DOCKETED	
Docket Number:	24-OPT-01
Project Title:	Perkins Renewable Energy Project
TN #:	257953
Document Title:	Perkins CEC Data Request Response Set #1 for the Opt-in Application 24-OPT-01 Part 1
Description:	Response Set #1 for the CEC Data Request for the Perkins Renewable Energy Project Opt-in Application 24-OPT-01
Filer:	Emily Capello
Organization:	Panorama Environmental, Inc.
Submitter Role:	Applicant Consultant
Submission Date:	7/23/2024 11:31:00 AM
Docketed Date:	7/23/2024

**California Energy Commission
Perkins Renewable Energy Project
CEC Data Request Response Set #1 for the
Opt-in Application 24-OPT-01**

CEC Data Request Response Set #1 for the Opt-in Application 24-OPT-01

Attachment F Updated Project Figures (DR PD-4)

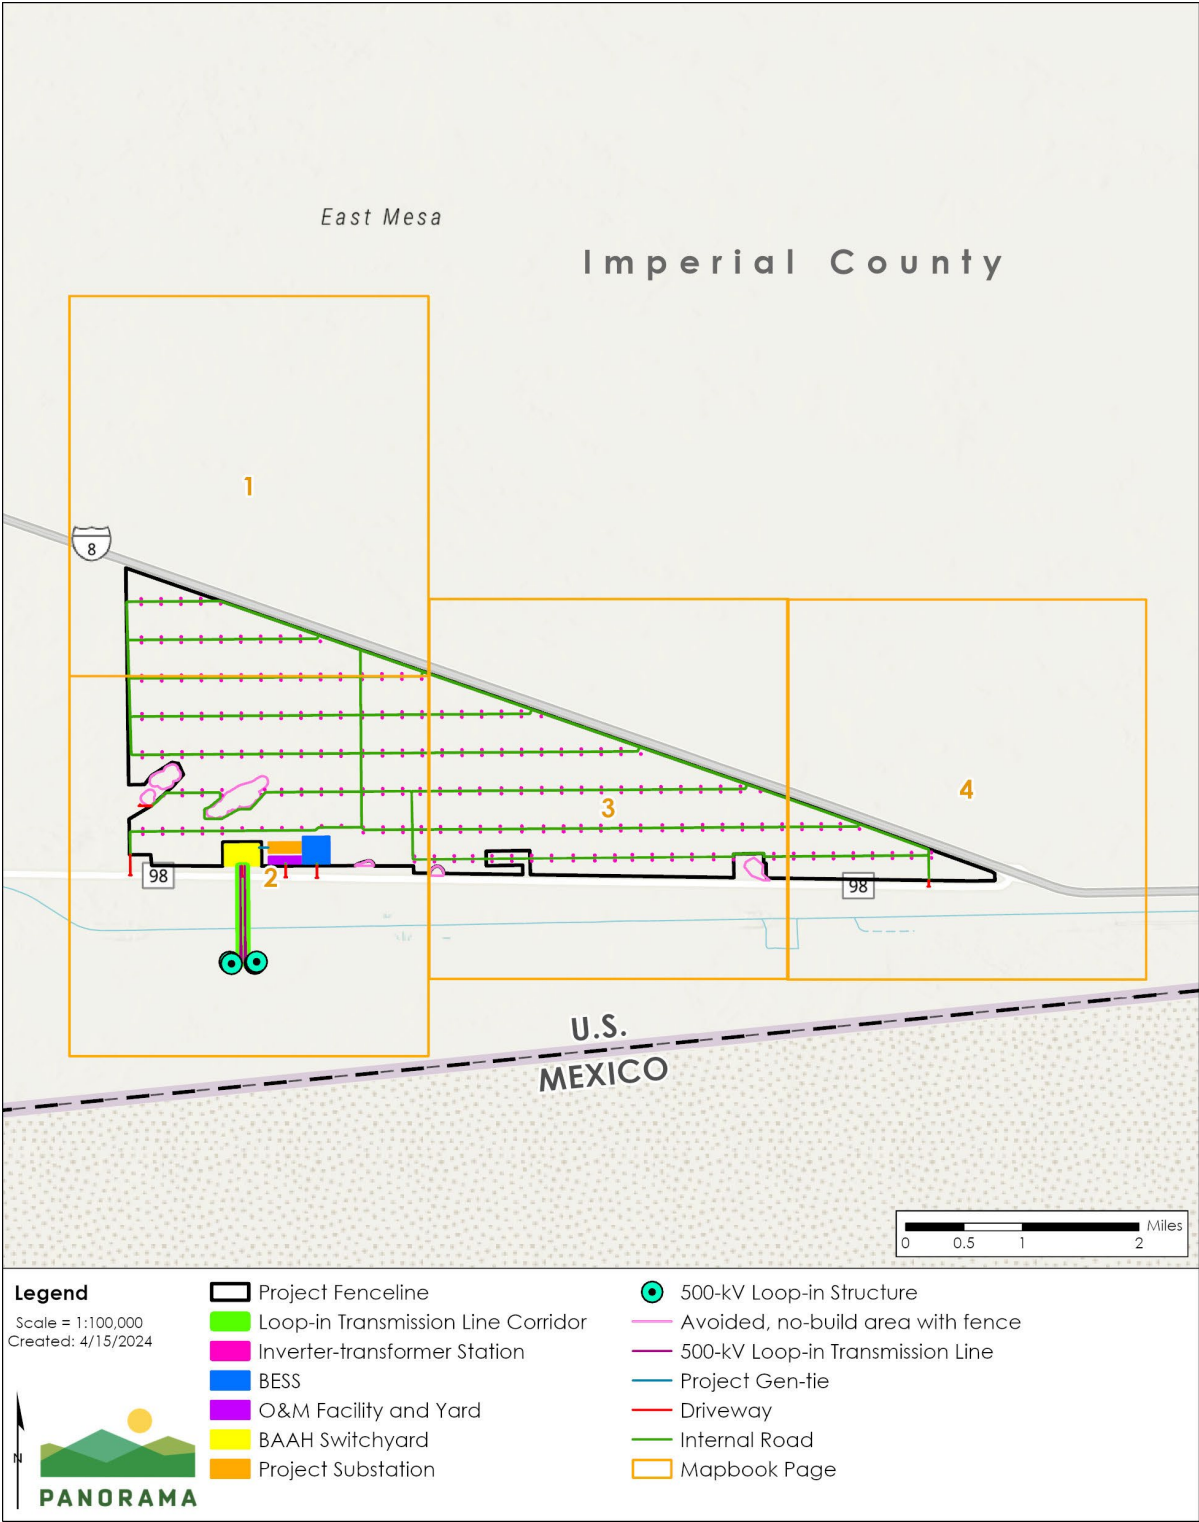
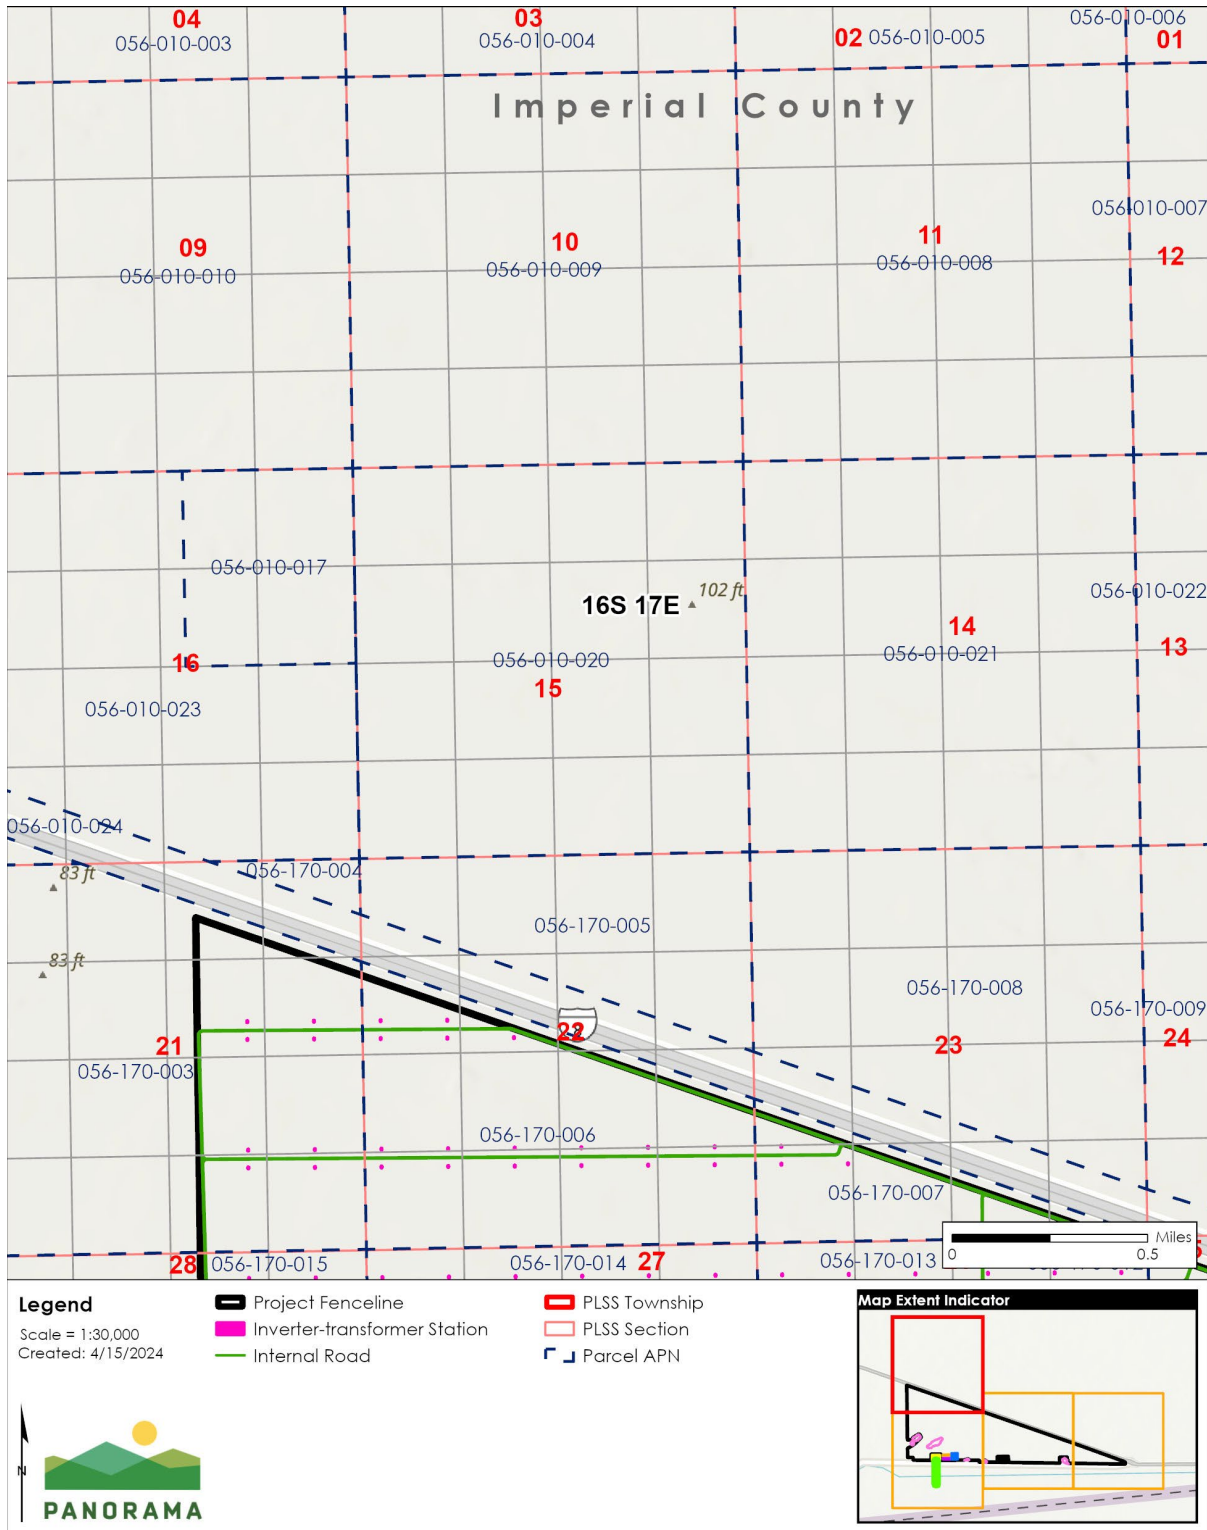
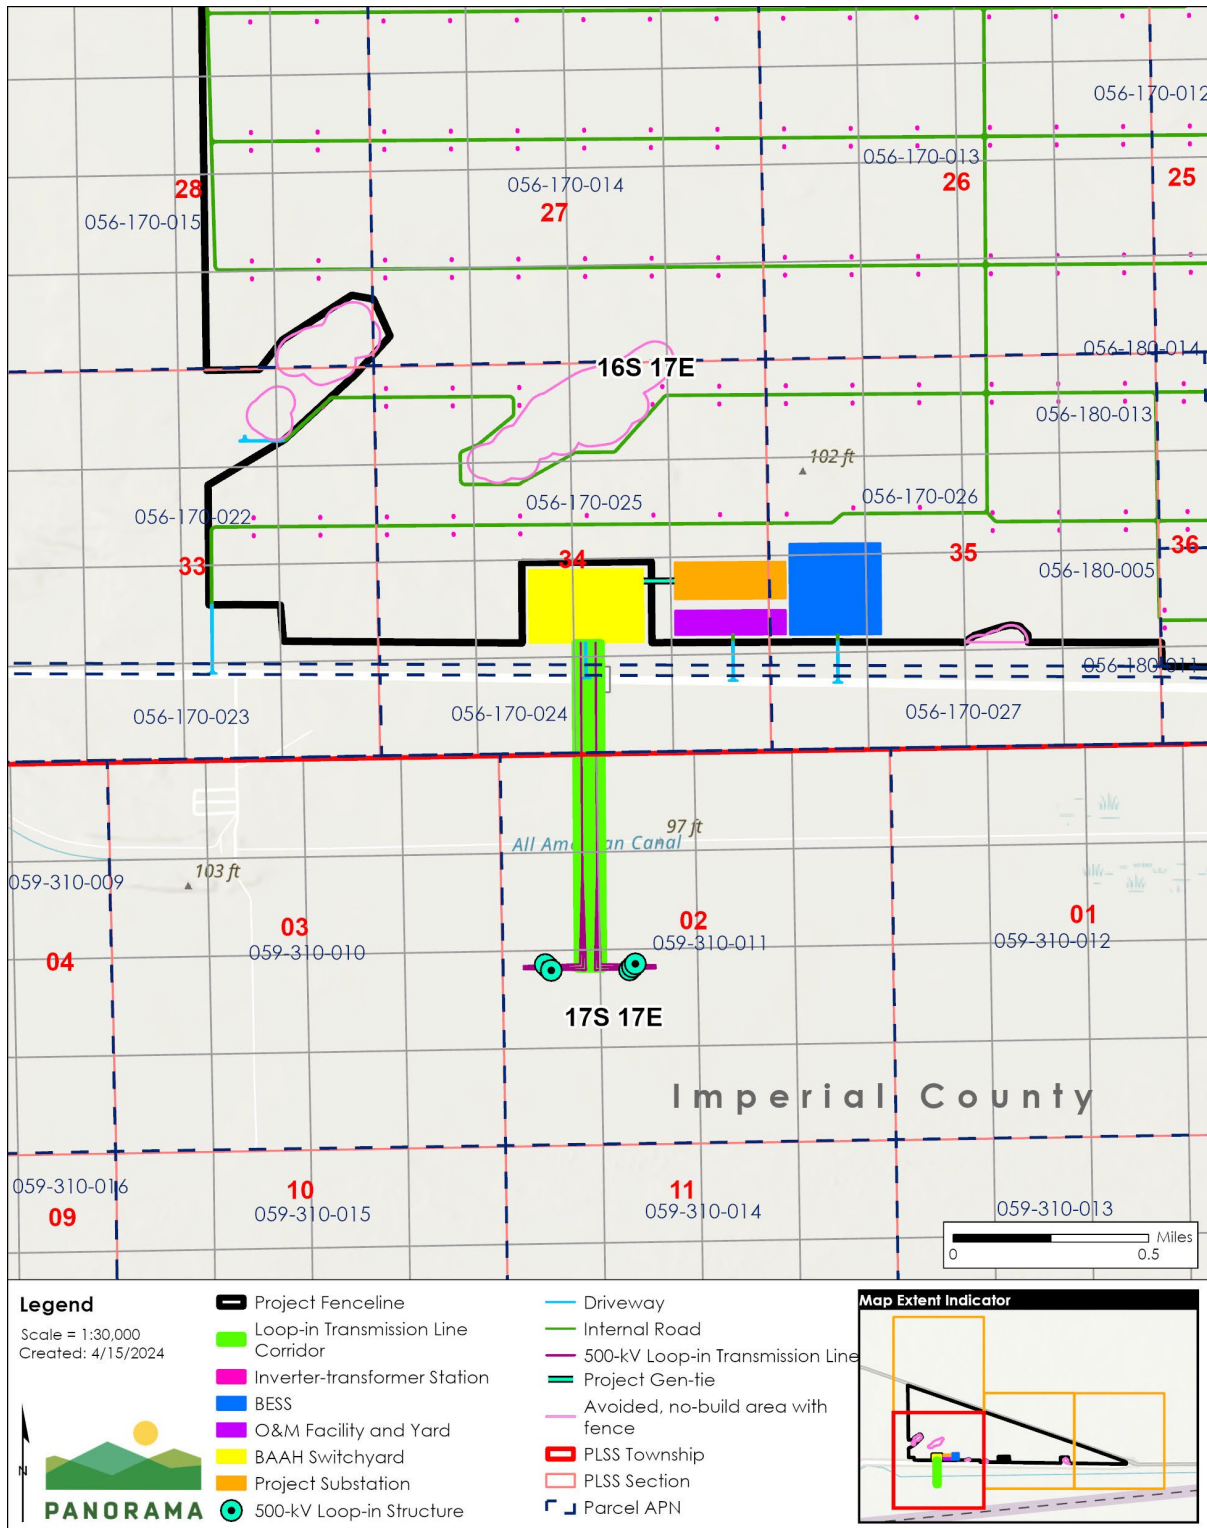
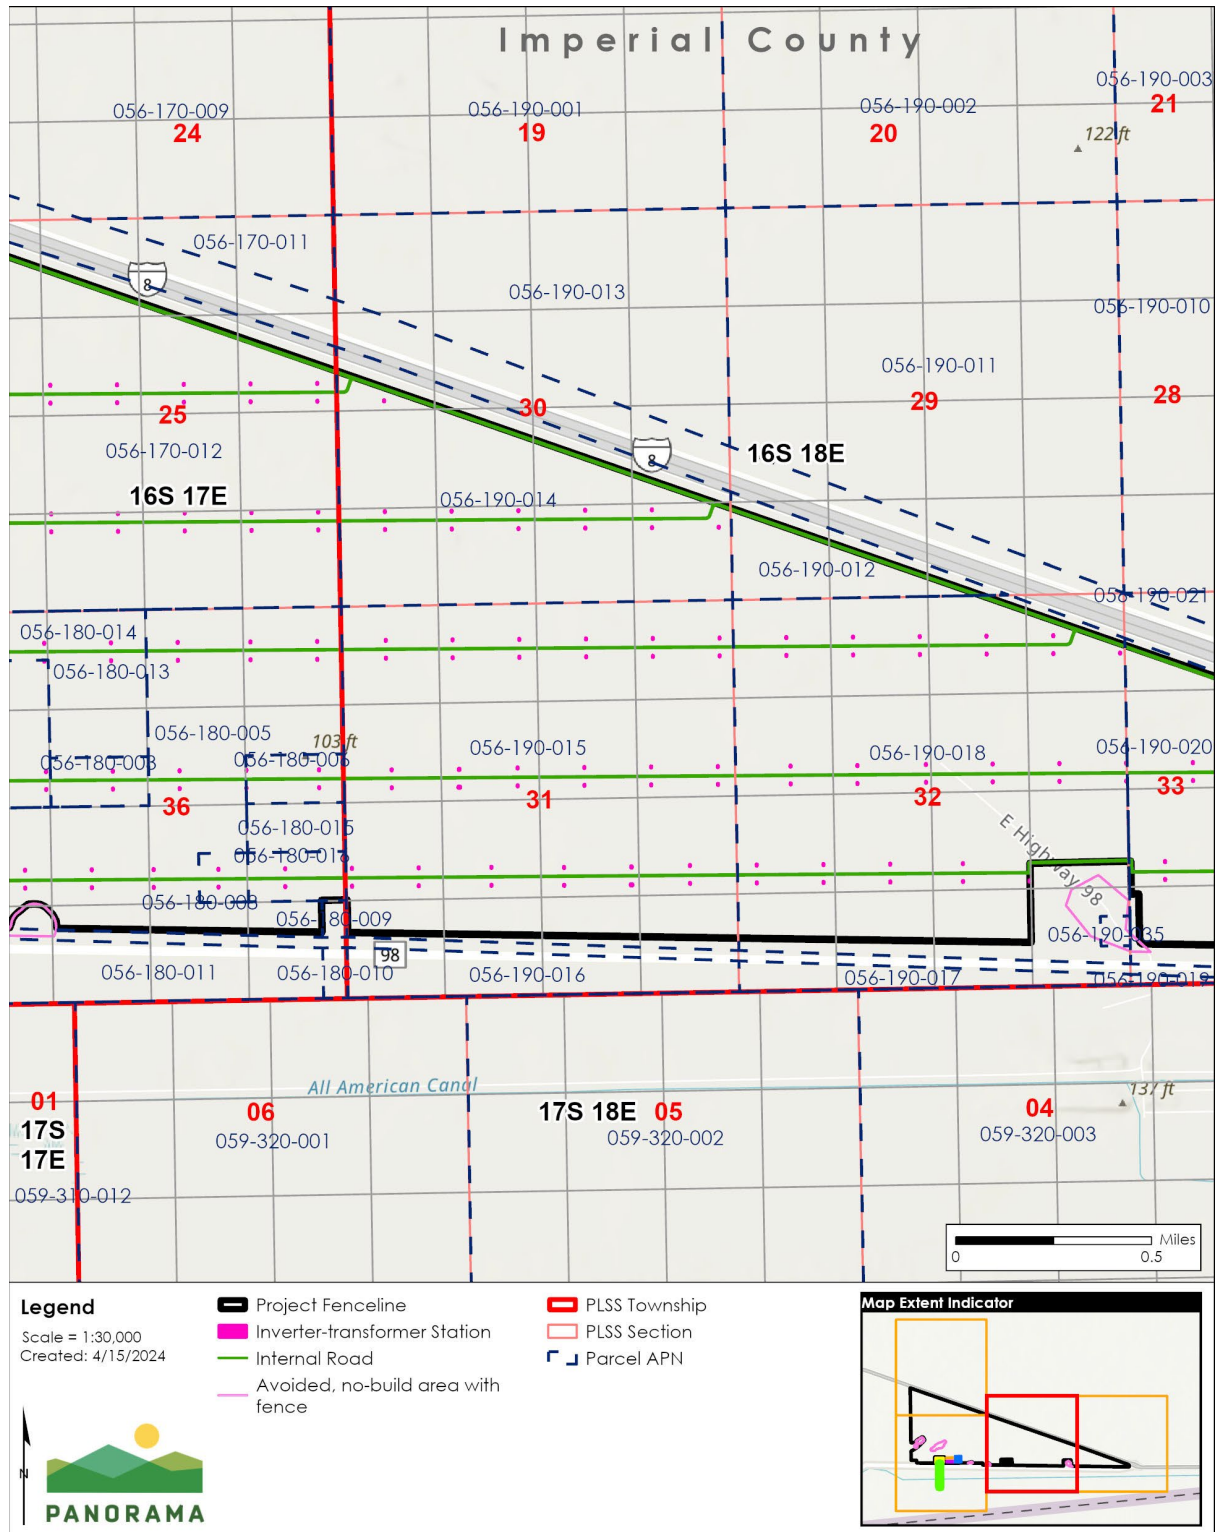
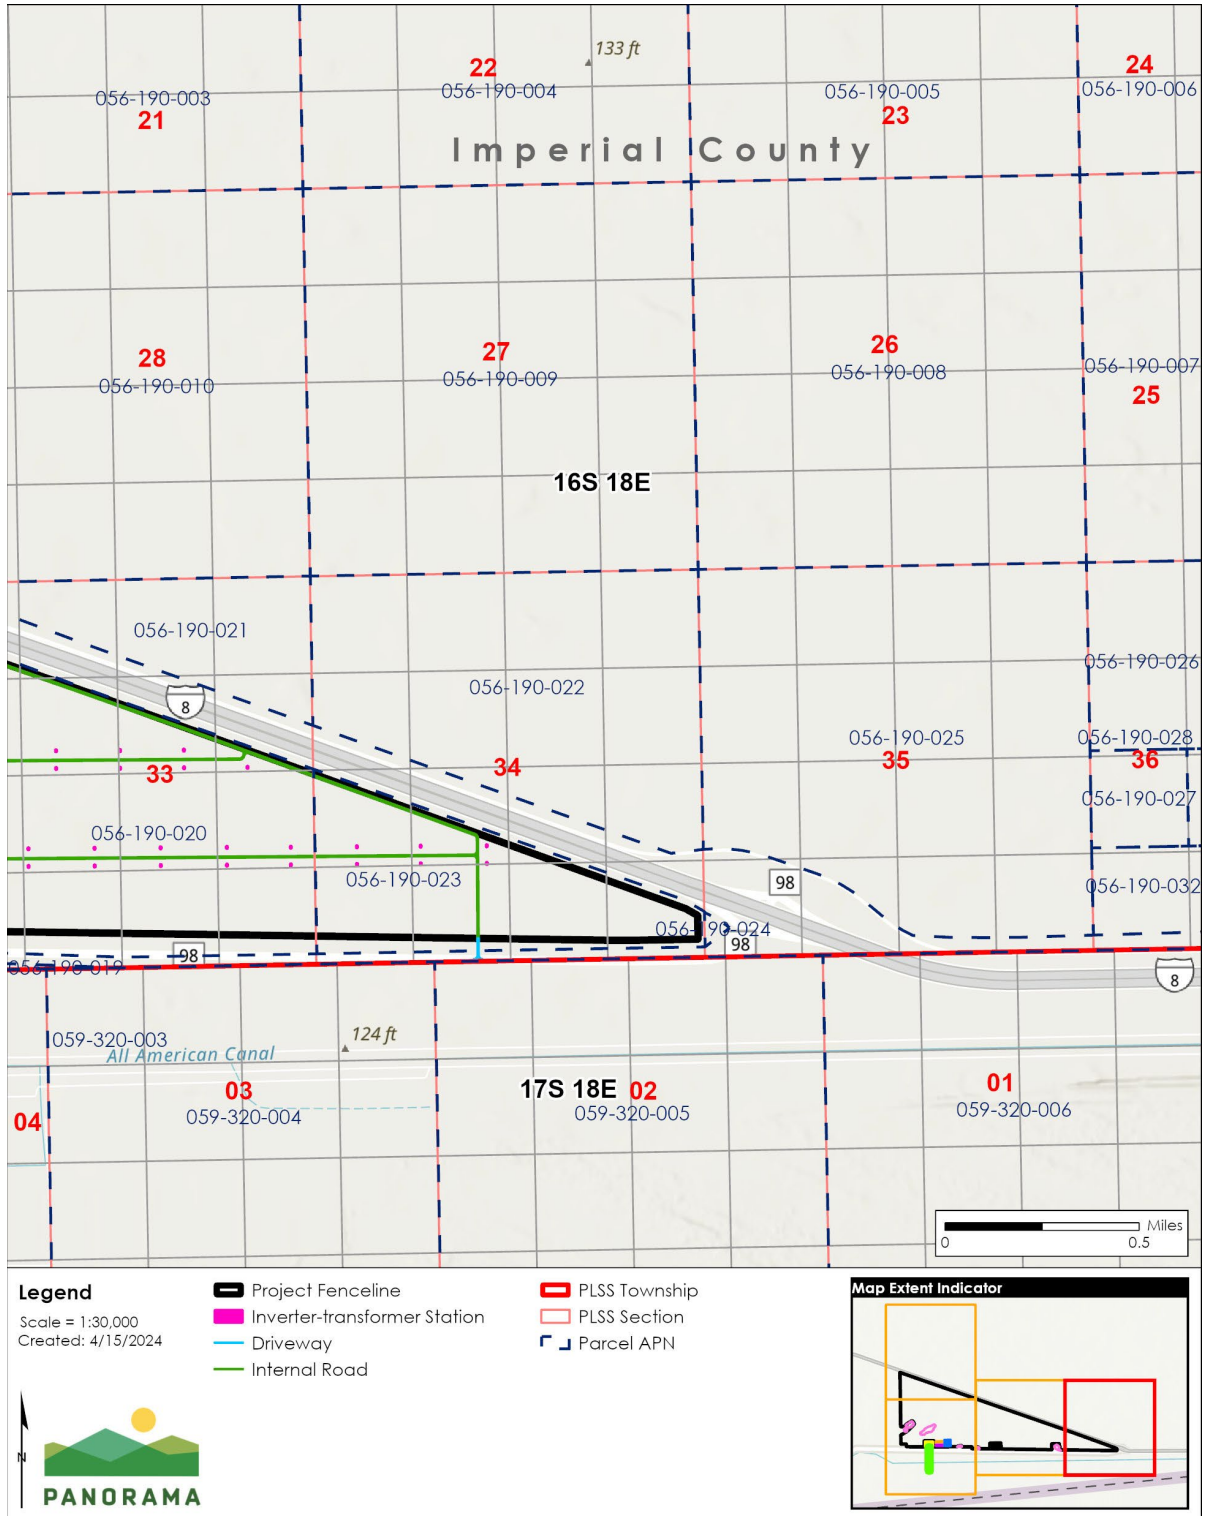
DR PD-4: Please identify and label the county on each map (Figures 6 to 11), please identify and label the county-international border on applicable maps; and please identify and label the township, range and section(s) in each figure title (Figures 7 to 11).
